PROPOSED TECHNICAL SPECIFICATION CHANGE

N TH ANNA UNIT NO. 2

ENGINEERED SAFETY FEATURE ACTUATION SYSTEM INSTRUMENTATION
SURVEILLANCE REQUIREMENTS

Figure 6.2-2 Facility Organization - North Anna - Units 1 & 2

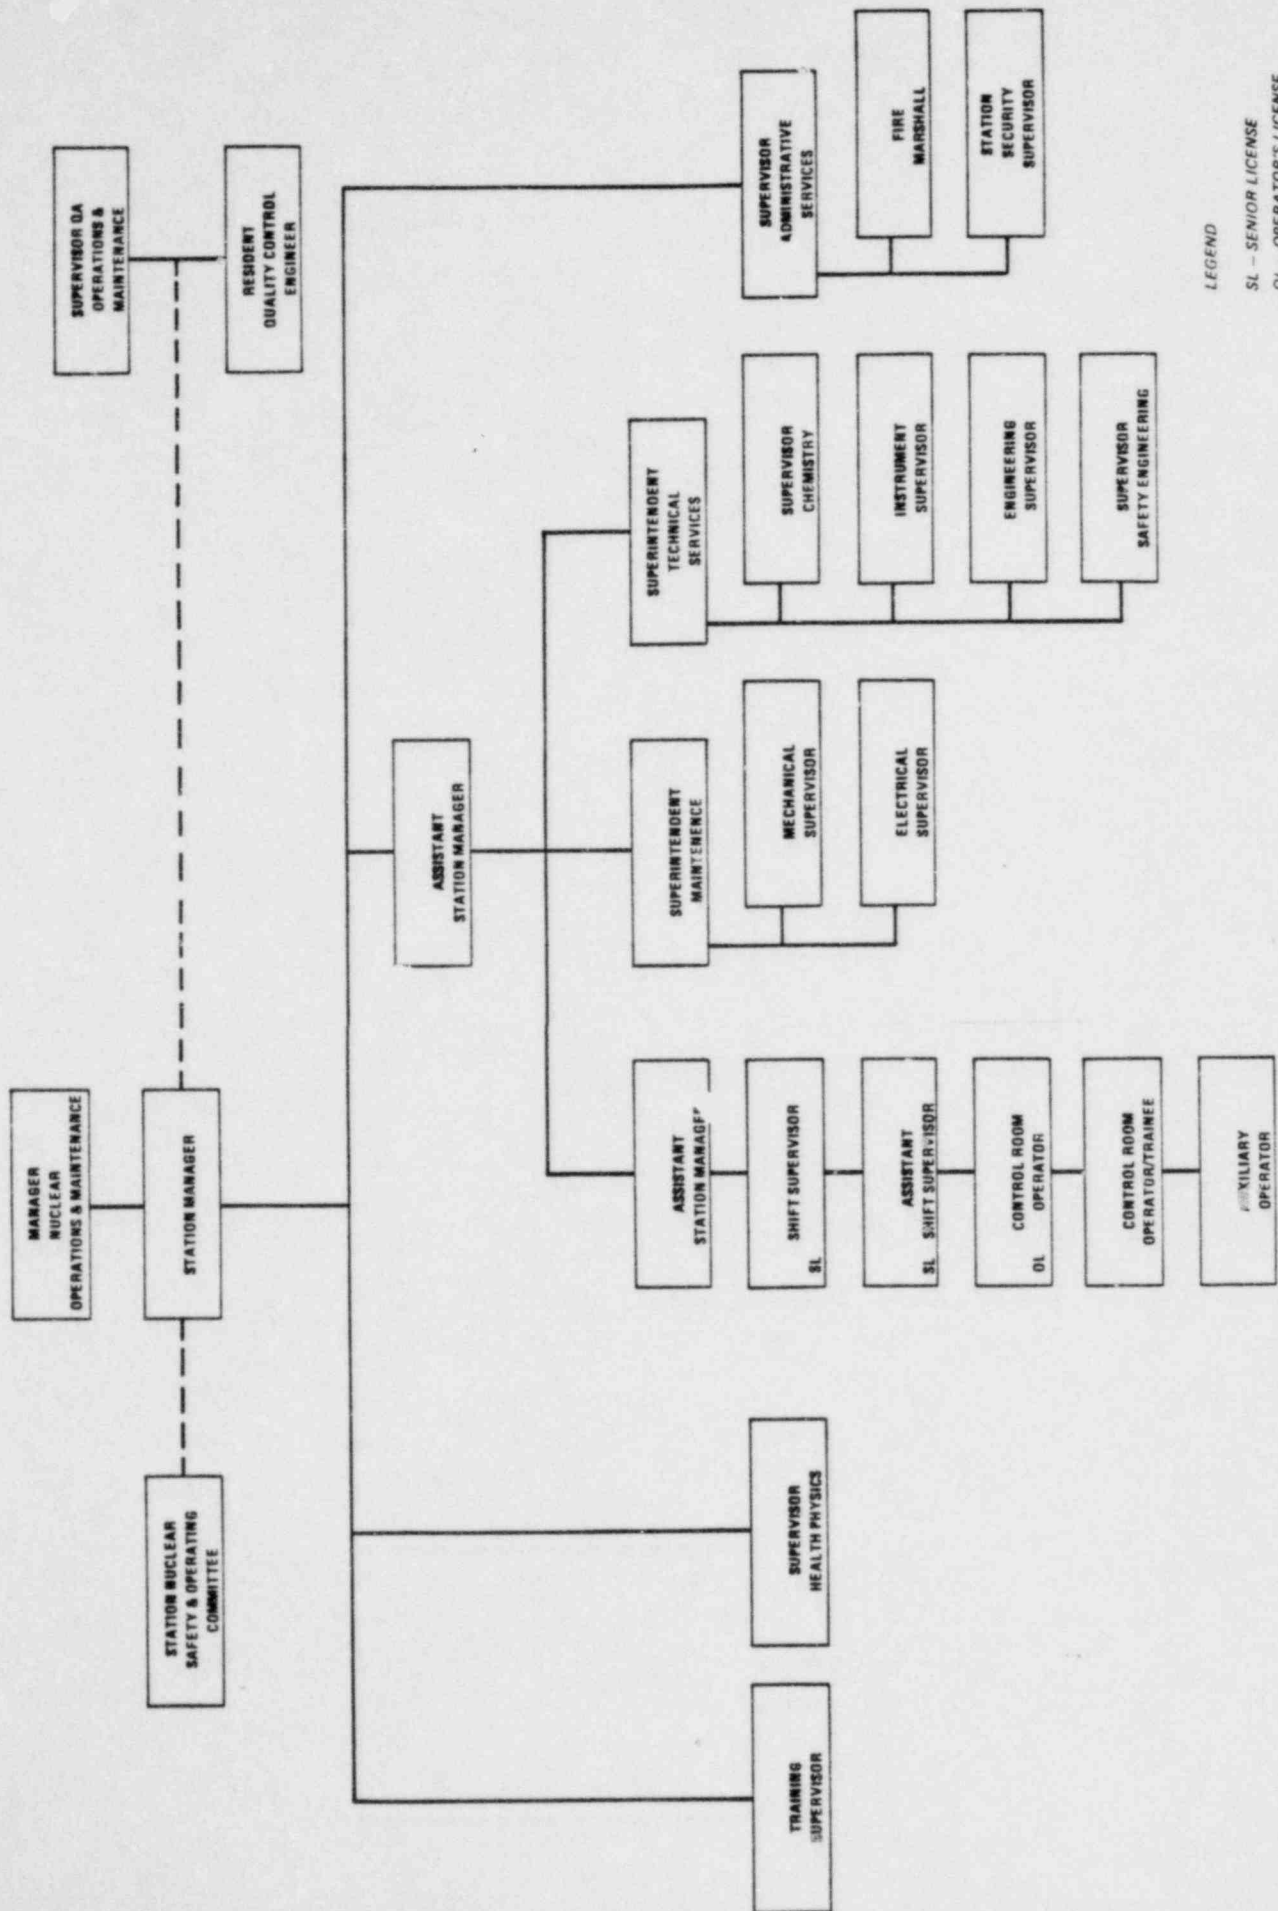
6.2.2 The Facility organization shall be as shown on Figure 6.2-2 and:
